Equipment Rules of Sailing

F.2.3 (e) Rigging Point

A submission from the Equipment Committee, Classes
Committee and 420 Class

(e) RIGGING POINT

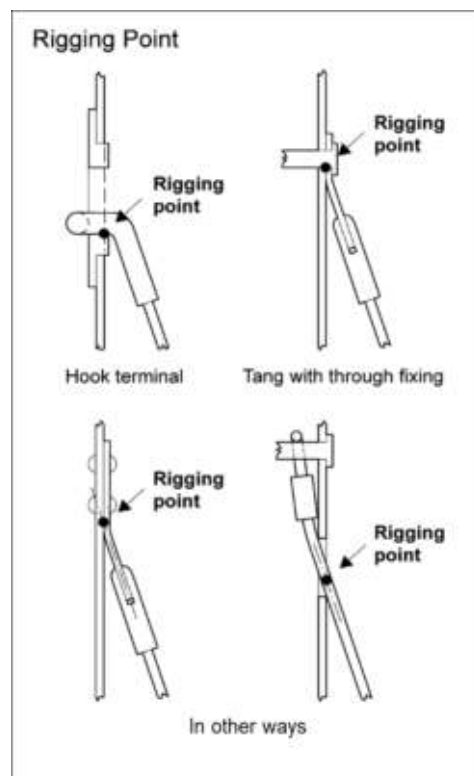
To remove obsolete examples from the definition and amend the drawing accordingly to match the text.

~~**BY EYE WITH BOLT OR OTHER THROUGH FIXING:** The lowest point of the **spar** bolt, or through fixing, where it intersects the **spar**.~~

1. The text and the drawing are not fully compatible. They are both updated to match the three main types of rigging point definitions.

When **rigging** is attached:

BY HOOK TERMINAL: The lowest point of the hook where it intersects the **spar**, extended as necessary.

BY TANG WITH THROUGH FIXING: The lowest point of the **spar** through fixing where it intersects the **spar**.

IN OTHER WAYS: The intersection of the outside of the **spar**, extended as necessary, and the centreline of the **rigging**.
